## PLANNING COMMISSION MEETING AGENDA

DECEMBER 2, 2025

**a. BCS Hopper Common Signage Plan**

**a. Metro by T-Mobile Variance**

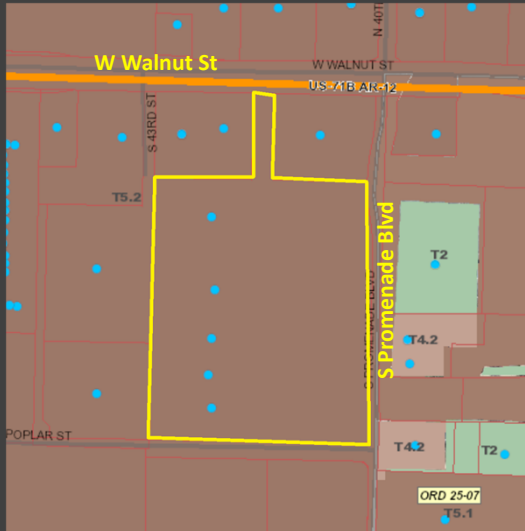
**Does the proposal minimize visual clutter and maximize readability and aesthetic appeal?**

The proposed signs are proportionate to the size of signs already in the shopping center.

**Does the proposal present a clear and public danger to public safety?**

No sign is this proposal is presented in a way that presents a clear danger to public safety.

### Visionary Proposed Signage Plan

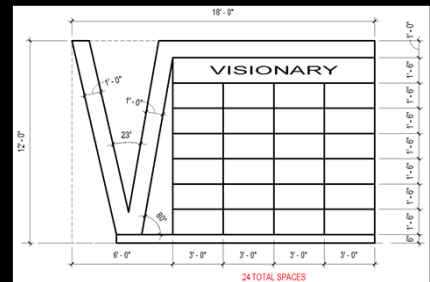
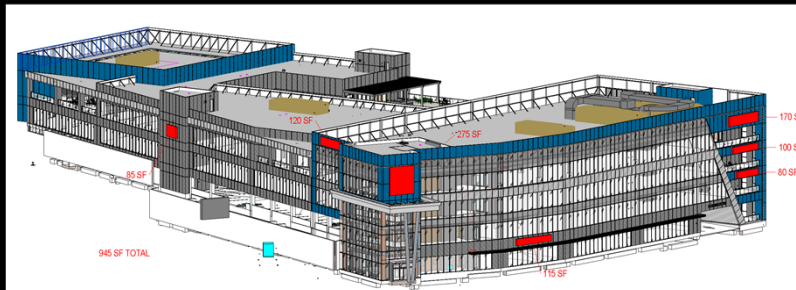
### Signs Compared to Code

- Wall signs:
  - The maximum allowed size of a wall sign is 30 square feet. The 7 wall signs range from 80 square feet to 275 square feet.
- Monument sign:
  - The maximum area of any monument sign shall not exceed forty-eight(48) square feet.
    - The proposed monument sign is 288 square feet.
  - The maximum height of any monument sign shall not exceed six (6) feet.
    - The height of the propose monument sign is 12 feet.

### Signs Compared to Code:

- Wall signs:
  - The maximum allowed size of a wall sign is 30 square feet. The proposed 7 wall signs range in size from 80 square feet to 275 square feet.
- Monument sign:
  - The code allows monument signs that are a maximum of 48 square feet in area and 6 feet tall. The proposed monument sign has an area of 288 square feet and is 12 feet tall.

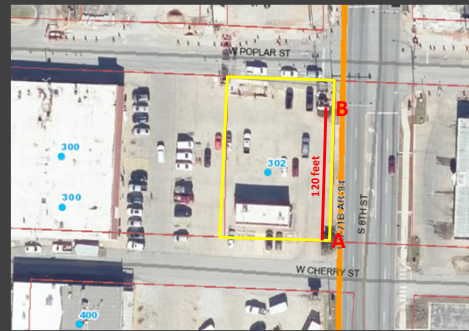
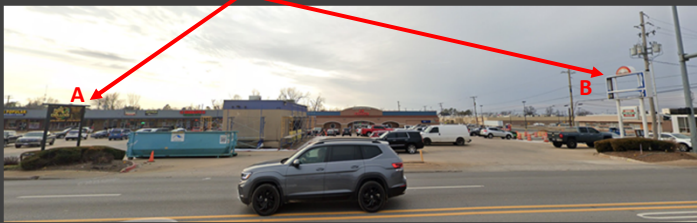
| <b>Would strict application of the code cause an undue hardship due to circumstances that are unique to this property?</b> | No. Due to the size of the building, its proximity to the street, and location near a signaled intersection, the requested size of the proposed signs is not warranted. The current banner on the building advertising the business is much smaller than the proposal, but it is still visible from the street for people driving by. The building is significantly closer to the street compared to the other surrounding businesses that have much smaller signs. |
| <b>Is the hardship a result of any action taken by the property owner or on their behalf?</b>                              | No. Before the 2024 tornado, there were other identifying marks on the building, but they had to rebuild. The sign code changed before the applicant applied for a sign permit, so the new code would apply to the request.                                                                                                                                                                                                                                         |

| Table 5.8.12.G Wall Signs |                |
| Quantity                  | One per tenant |
| Area (square feet)        | 30             |

- See slide for responses to the variance criteria.
